Private Plan Change request – McKinney Road, Warkworth

Stantec is pleased to provide the following response to the Clause 23 request for further information received from Auckland Council on the above project.

Figure 2: Pedestrian / Cycle access

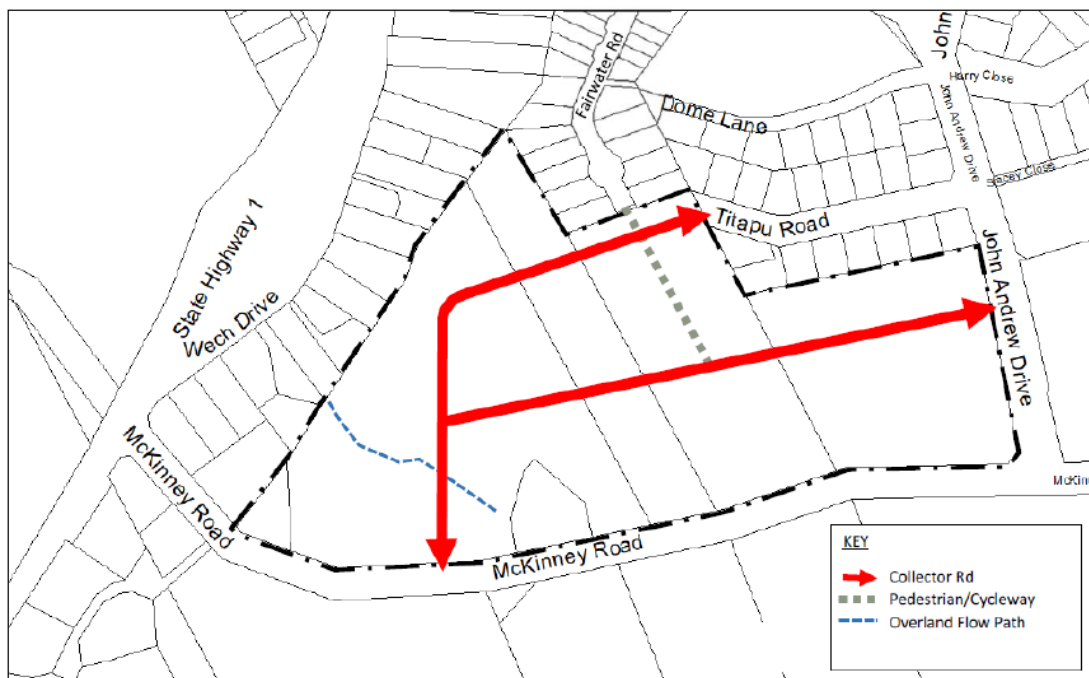
“Please confirm if corridor upgrades, particularly fronting the plan change area, will be provided.”

Reason: “John Andrew Drive is included on the walking and cycling network as well as the public transport network in the Warkworth Structure Plan, while McKinney Road is also included in the walking and cycling network. The ITA also comments on a pedestrian desire line travelling north at the intersection of McKinney Road and SH1.”

Although John Andrew Drive and McKinney Road are included in the walking and cycling network, the main active mode access is provided from Fairwater Road, connecting to the new Collector Roads, illustrated in **Figure 2**. Frontages along McKinney Road and Don Andrew Drive will be established with AT standards during the development stage.
